**GENOA CHARTER TOWNSHIP
PLANNING COMMISSION PUBLIC HEARING
NOVEMBER 9th, 2020
6:30 P.M.
AGENDA**

Attention:	Kelly Van Marter, AICP Planning Director and Assistant Township Manager
Subject:	The Prophet Elijah Retreat Center – Special Land Use and Site Plan Review #3
Location:	1391 Kellogg Road – southwest corner of the Kellogg Road/McClements Road intersection
Zoning:	PRF Public and Recreational Facilities District

E6 Ground Sign - Plan
A011 SCALE: 3/4" = 1'-0"

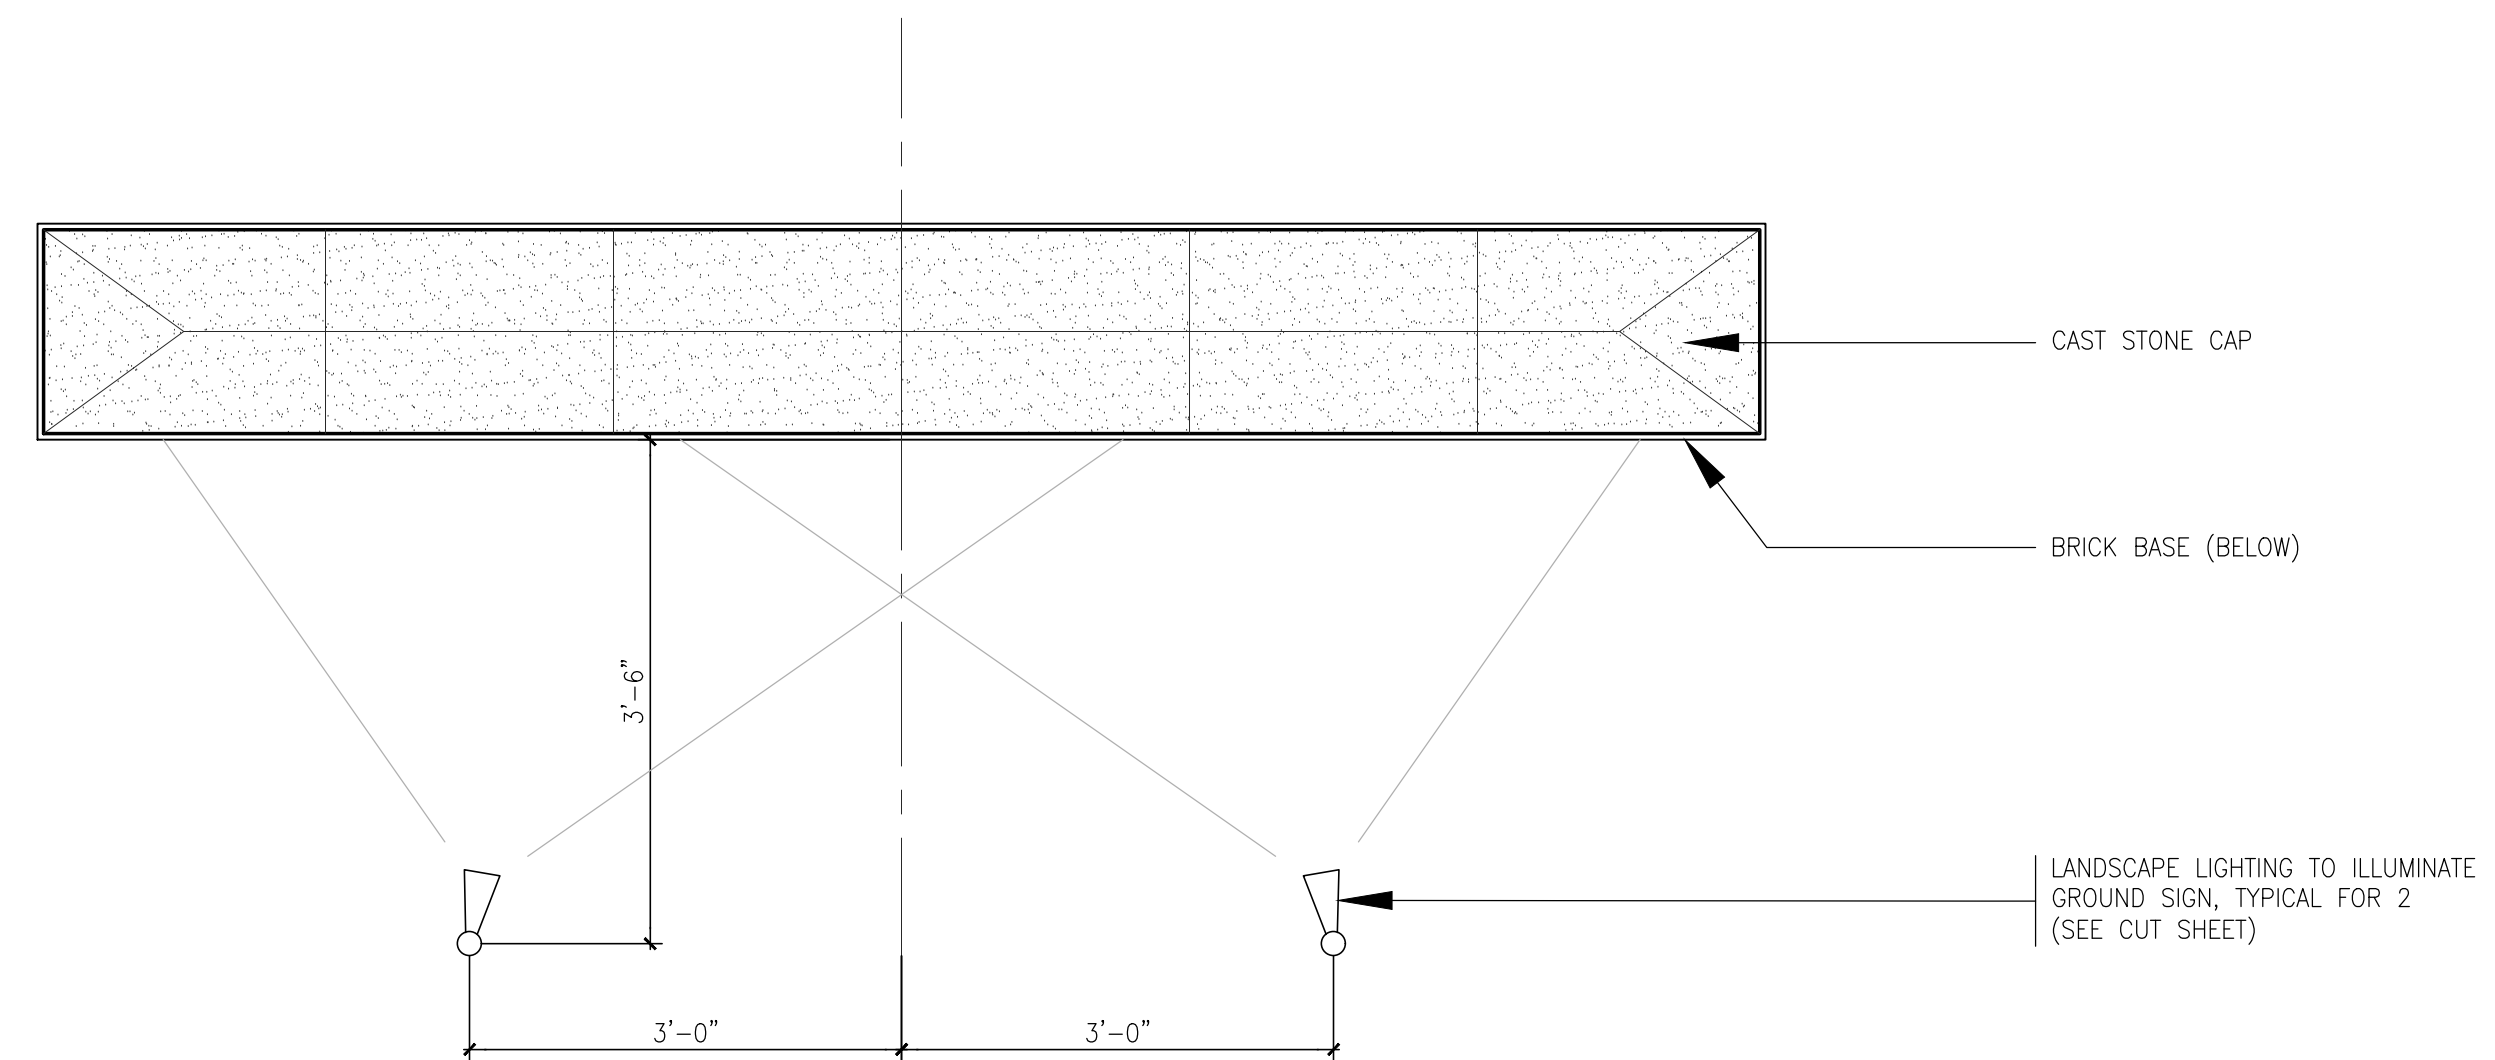
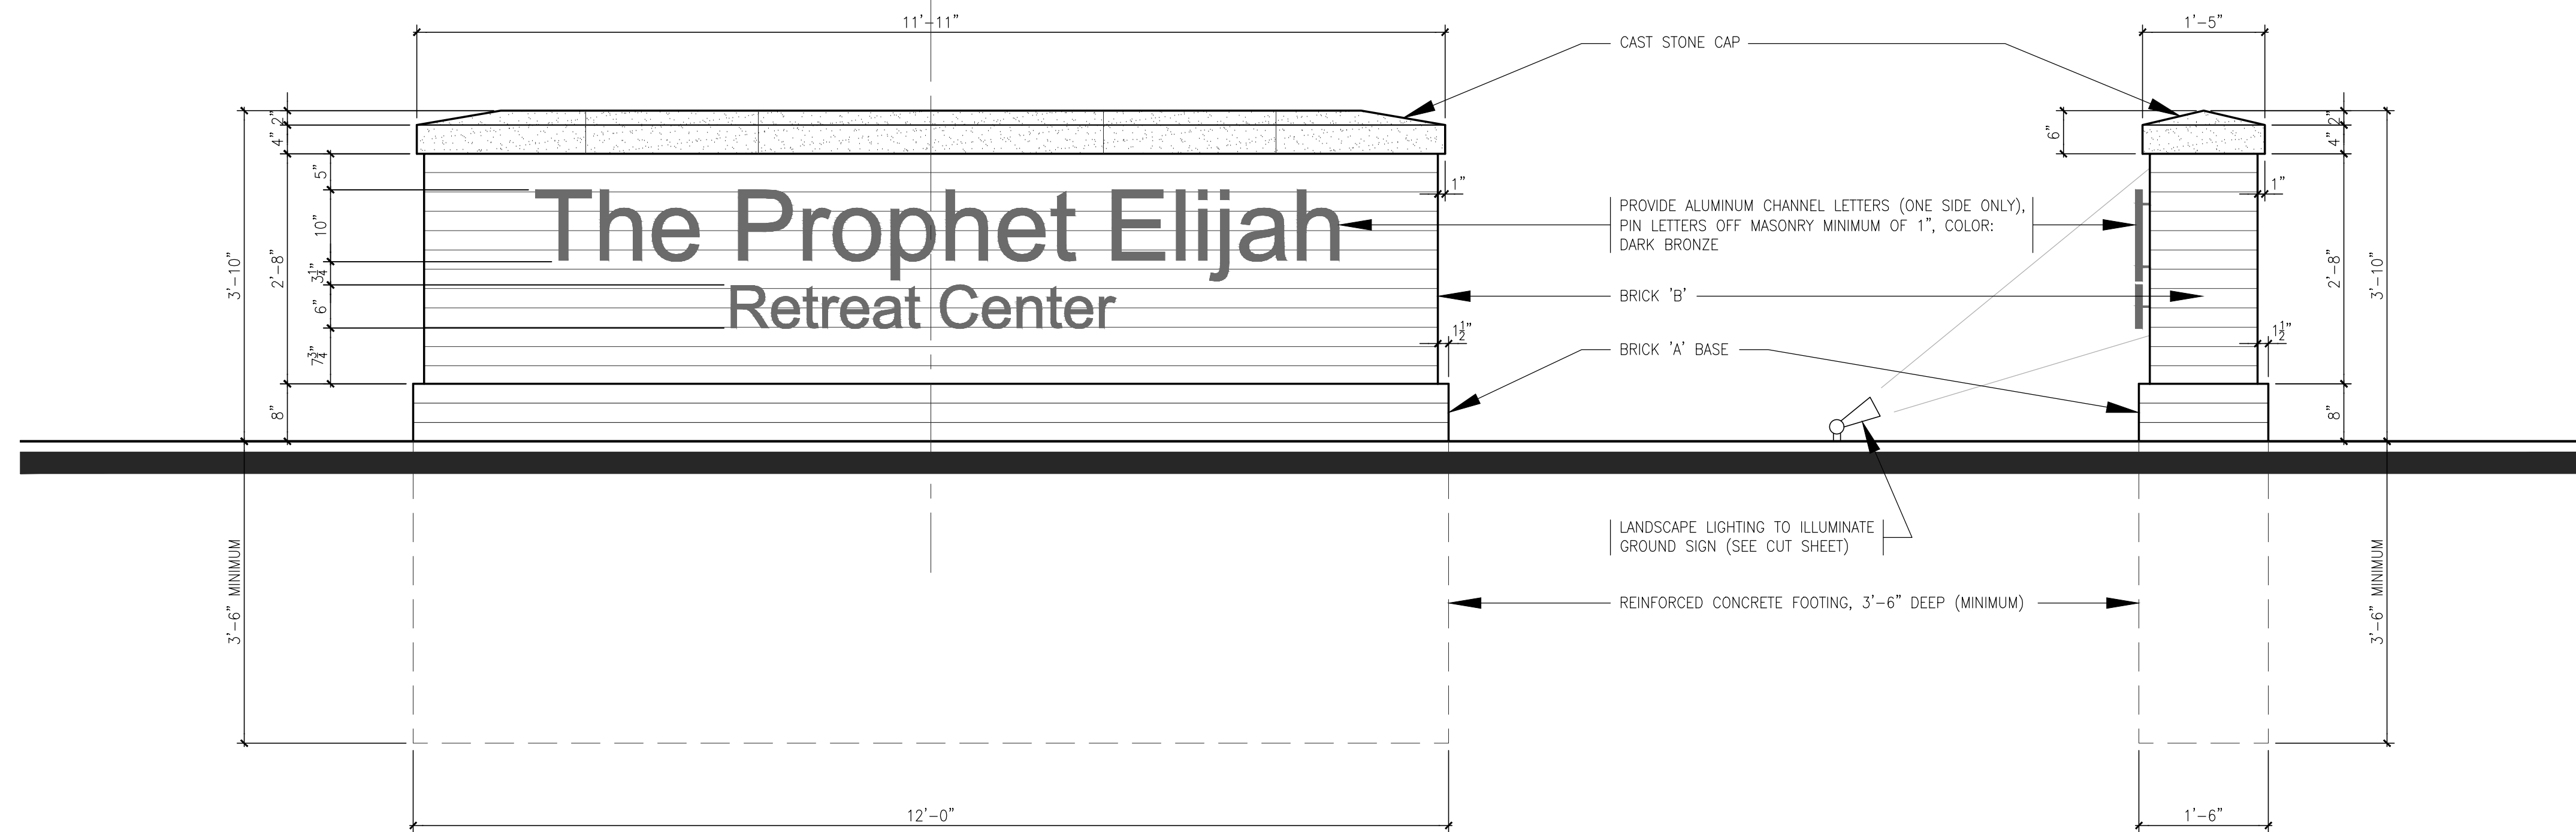
- 9. Signs.** The plan includes a new monument sign internal to the site (south of the proposed parking area). Details on Sheet A011 depict a masonry structure (brick and stone) with metal channel-cut lettering.

WEST ELEVATION

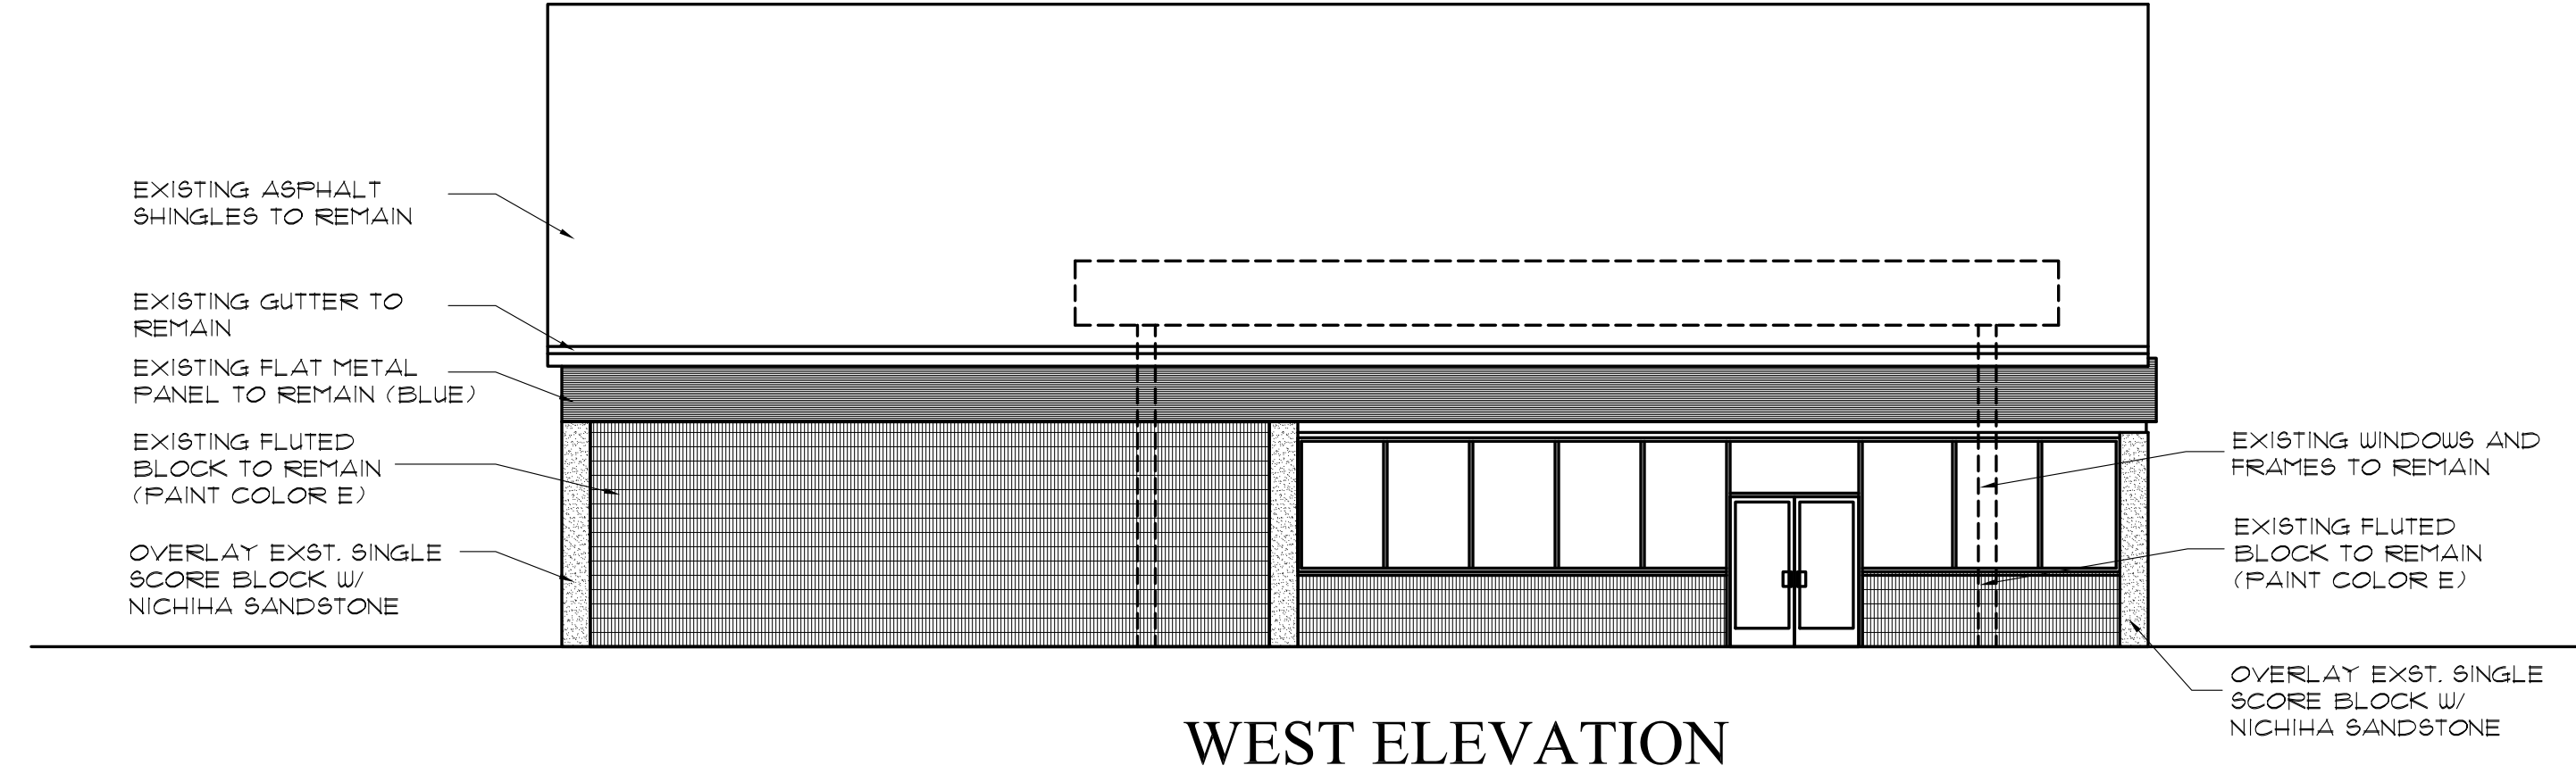
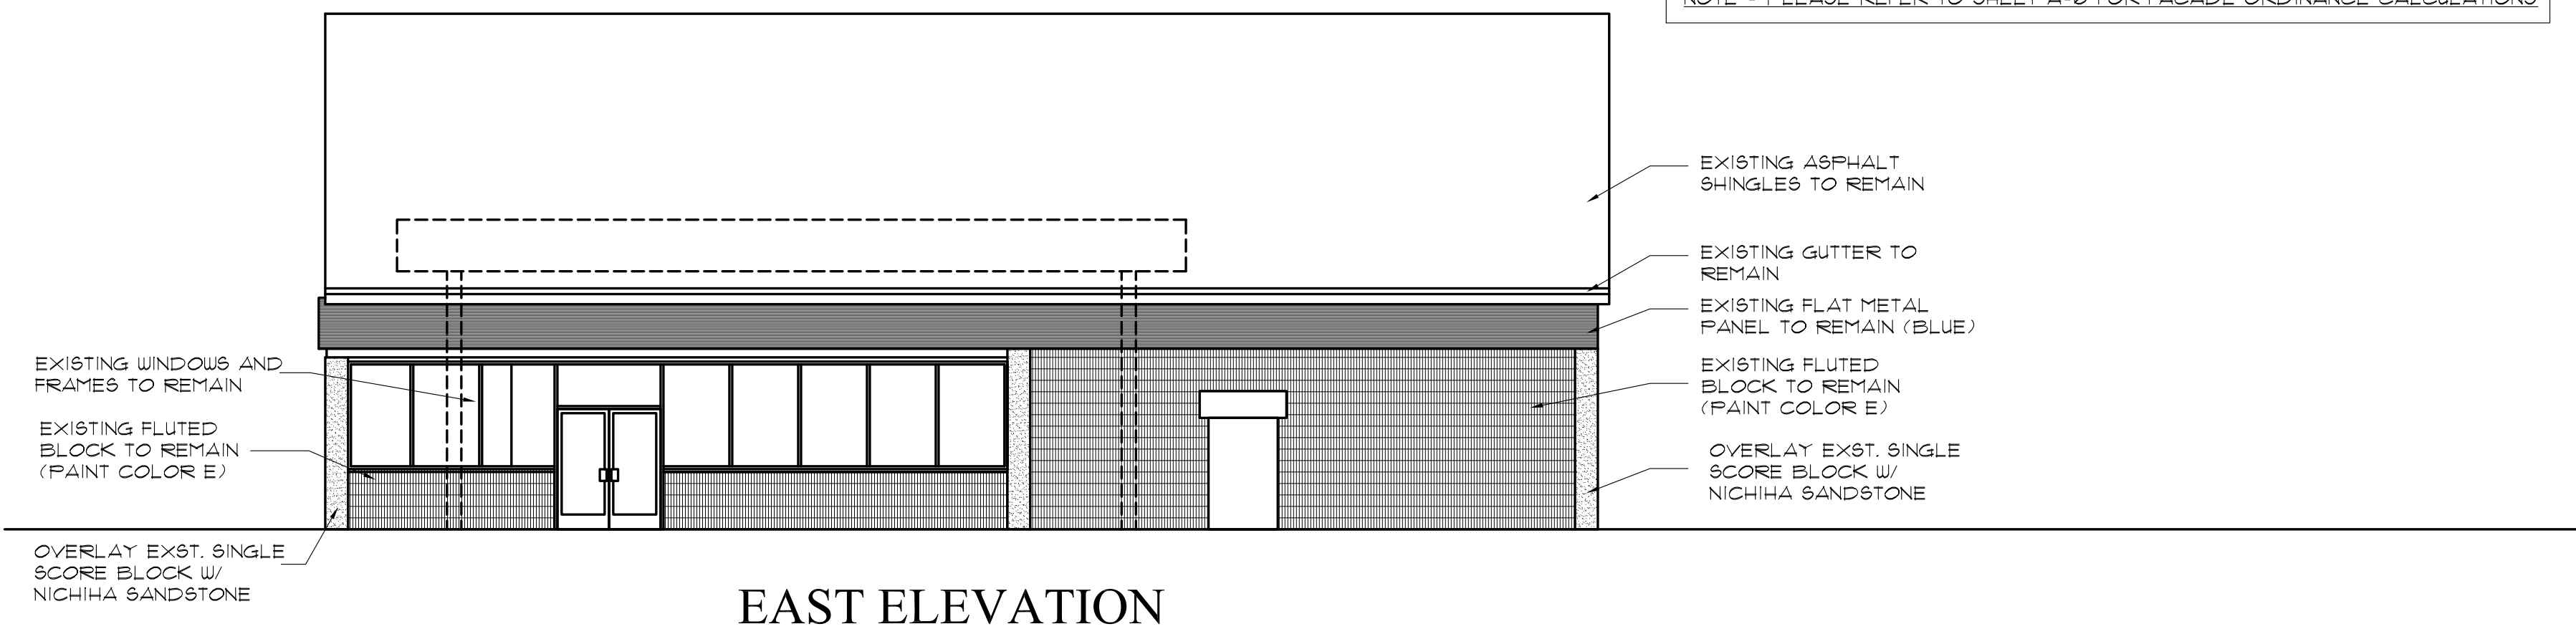
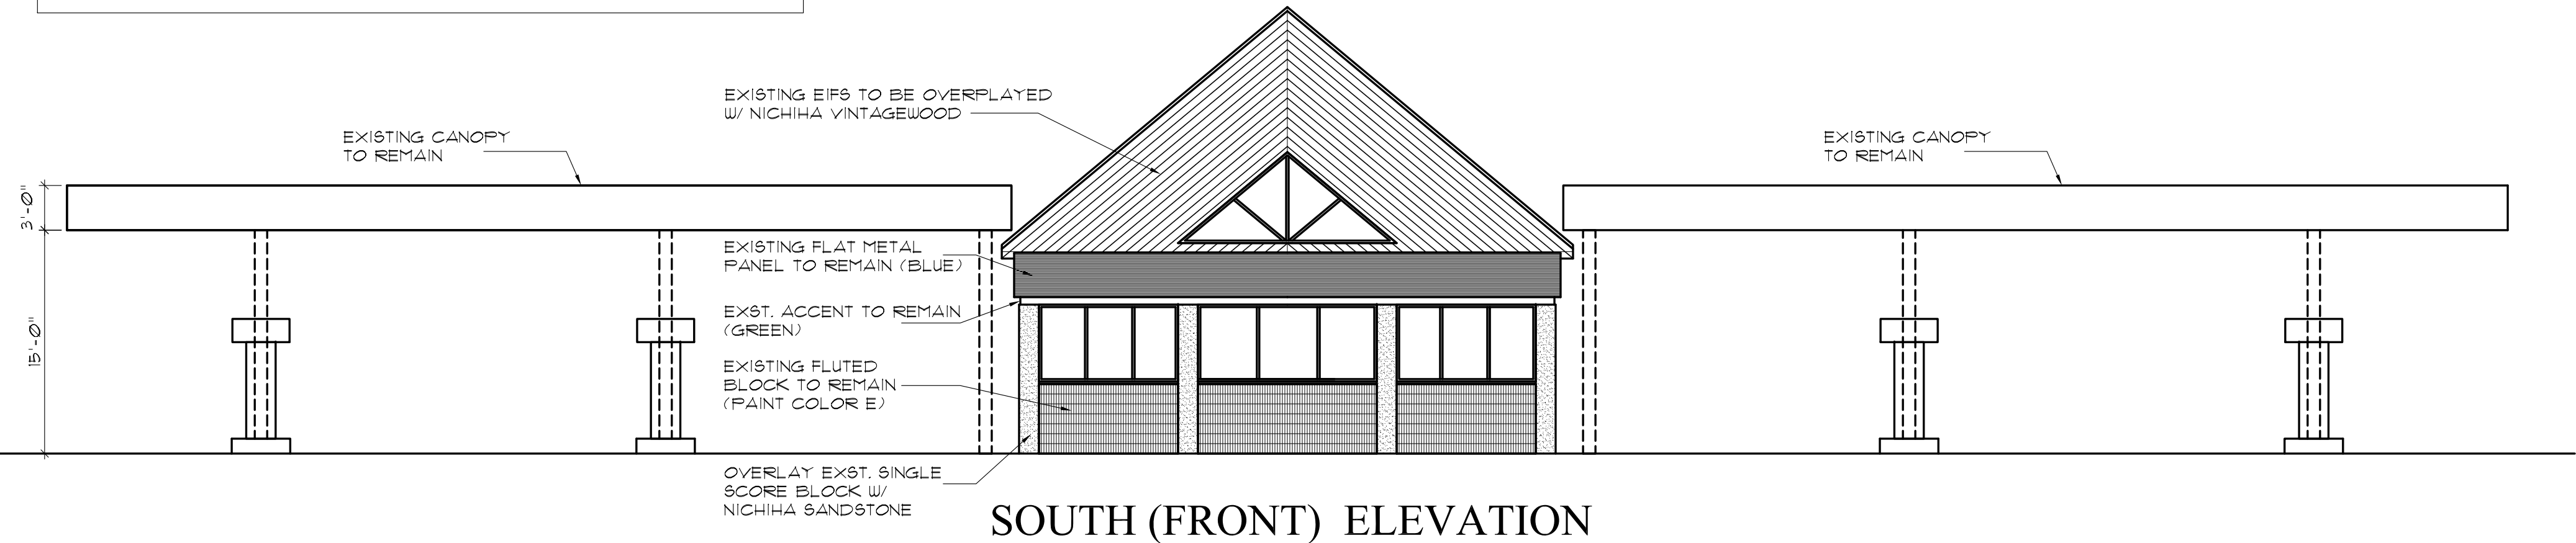
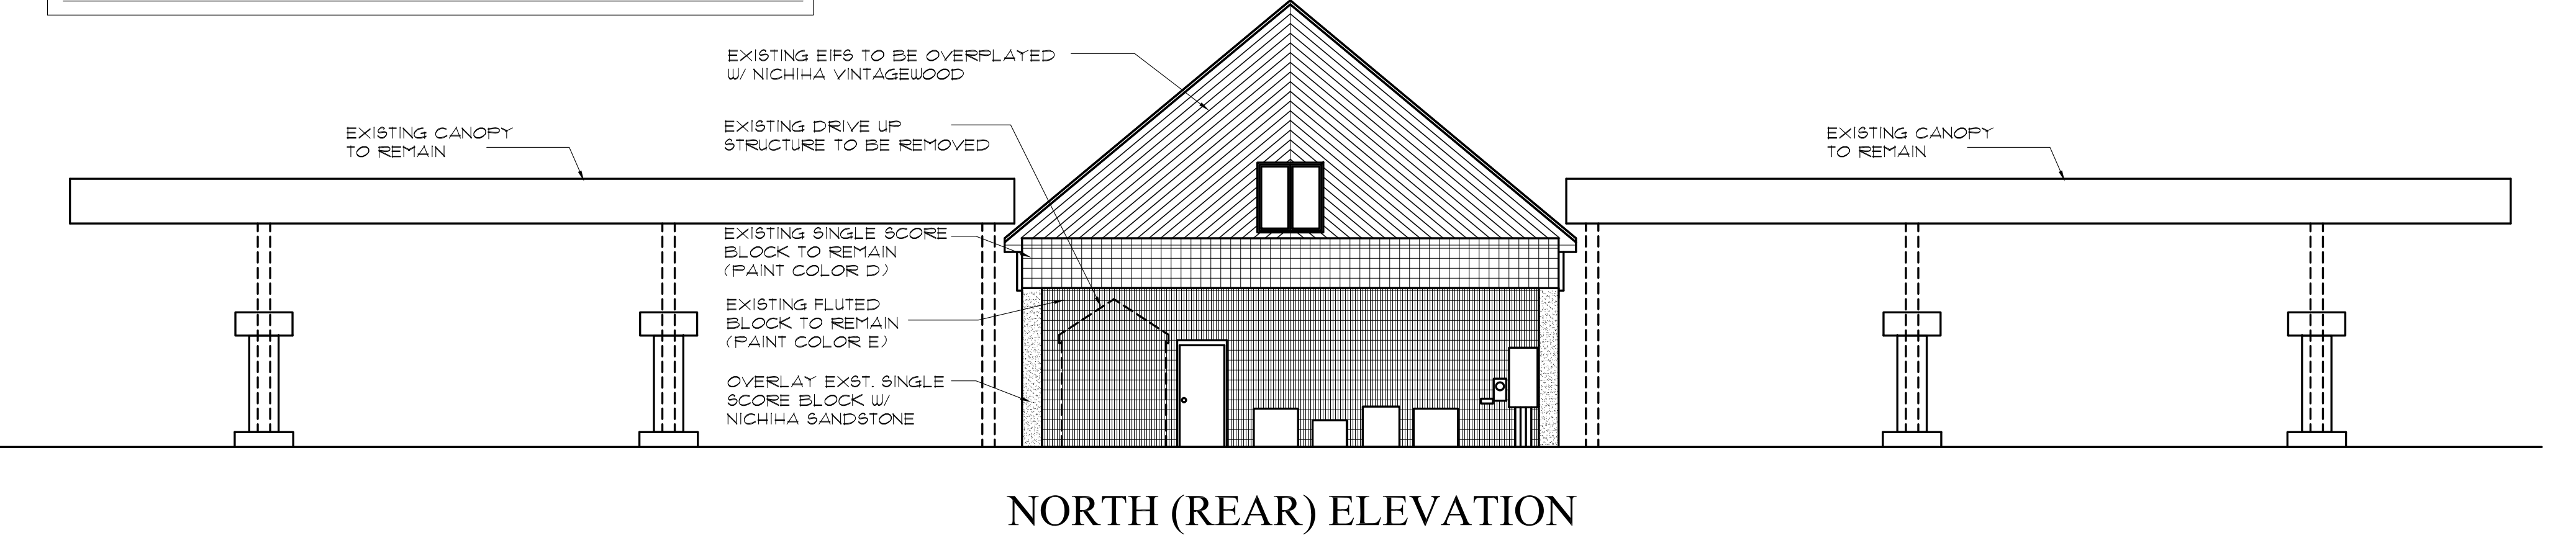
3. Sheet A-6, which includes building material calculations, was not included in the materials submitted to our office.
4. We request the applicant present building material and color samples to the Commission.

The proposed elevations and materials for both buildings are consistent with the approved Conceptual PUD Site Plan; however, there are references to material calculations on Sheet A-6, which was not included with the materials submitted to our office.
